Subject: AP1000 Response to Request for Additional Information (TR 85)

Response to Request for Additional Information on Technical Report No. 85

RAI Response Number: RAI-TR85-SEB1-10

RAI Response Number: RAI-TR85-SEB1-37
Revision: 2

Figure RAI-TR85-SEB1-3510-1 – Passive Pressure versus Deflection at Grade (North-South Excitation)

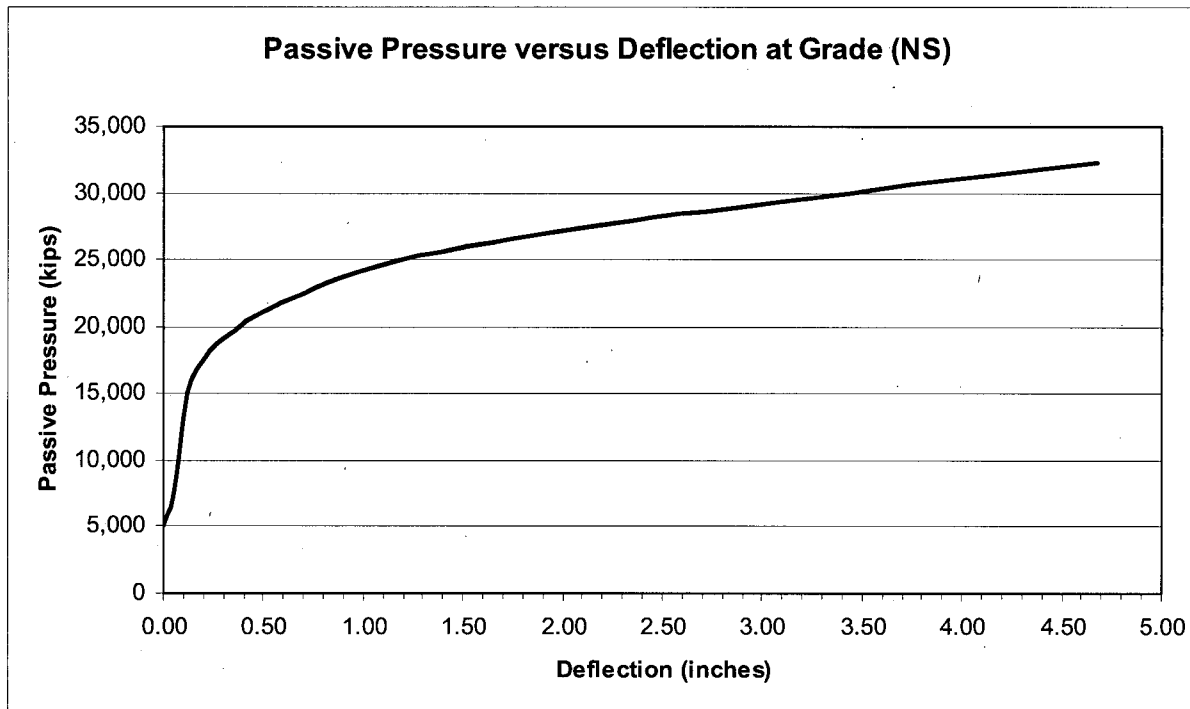
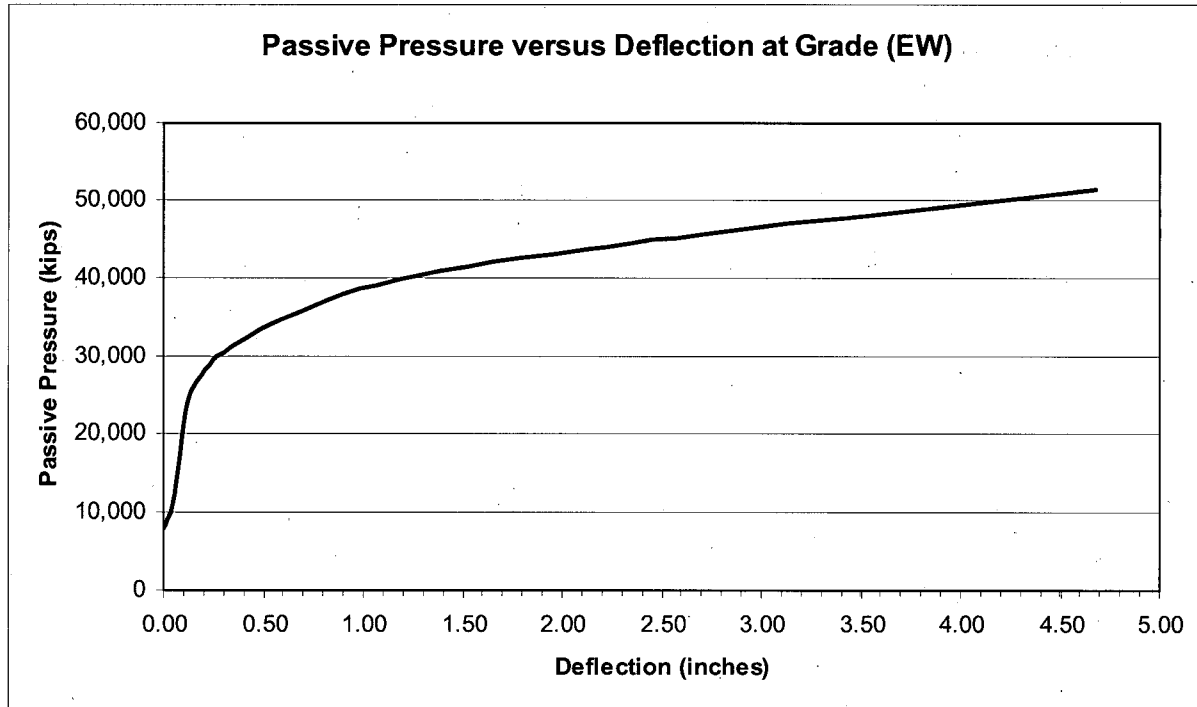
In the response for item b of the RAI, Westinghouse indicated that the analysis for stability has been revised to utilize the 3D ANSYS finite element NI20 model using a mode superposition time history analysis (linear with no lift-off). A separate 2D ANSYS lift-off analysis demonstrated that the minor lift-off is negligible. Since the 3D ANSYS NI20 model analysis using three input motions applied simultaneously is utilized for the stability evaluation, the concern raised by the directional combination methods no longer applies. Therefore, this concern has been adequately addressed. However, the RAI response discussed the need to utilize some passive pressure resistance capability of the soil when performing the sliding stability analyses. The passive pressure resistance curve as a function of displacement is based on Reference 1 (Hsai-Yang Fang, "Foundation Engineering Handbook," 1991) given in the RAI response. Westinghouse is requested to provide the complete text in the applicable section or chapter of the referenced book which describes the approach for determining the passive pressure resistance function.

In the evaluation of sliding different coefficients of friction are considered. They are 0.7, 0.6, and 0.55. Also, it is necessary to rely on passive pressure. Using Case 15 (RAI-TR85-SEB1-35, R1, Table RAI-TR85-SEB1-35-1), and the methodology given in Reference 1 using a soil friction angle of 35°, a relationship between passive pressure and displacement at grade elevation can be defined. This relationship is shown in Figures RAI-TR85-SEB1-3510-1 and RAI-TR85-SEB1-3510-2 for the first 5 inches of deflection. Curves are given for the North-South and East-West directions. The passive pressure at zero deflection is equal to the at rest pressure. The total passive soil pressure resistance force is 43,500 kips for the North-South direction, and 69,100 kips for the East-West direction. It is noted that to achieve the full passive pressure displacements in excess of 10 inches are required.

During the sliding stability calculation it was determined that the factor of safety for sliding drops below the limit of 1.1 for a very short time if passive pressure is not considered. Plots of the factor of safety (FS) versus time for the hard rock case and the North-South and East-West directions are given in Figures RAI-TR85-SEB1-3510-3 and RAI-TR85-SEB1-3510-4 using a coefficient of friction of 0.55. As seen from these figures the time at which the factor of safety drops below 1.1 is very short. This is the only time during the seismic event that this occurs. When the passive pressure is considered, the factor of safety remains above the limit of 1.1.

In Tables RAI-TR85-SEB1-3510-4-3 to RAI-TR85-SEB1-3510-3-5 are given a summary of the results for the three coefficient values. Provided is the required passive pressure to maintain the factor of safety equal to or above 1.1. As seen from this summary using a coefficient of friction of 0.55 or higher, deflections less than 0.15 inch for hard rock, less than or equal to 0.5 inch for upper bound soft to medium and soft to medium soil conditions are needed to develop the required amount of passive pressure.
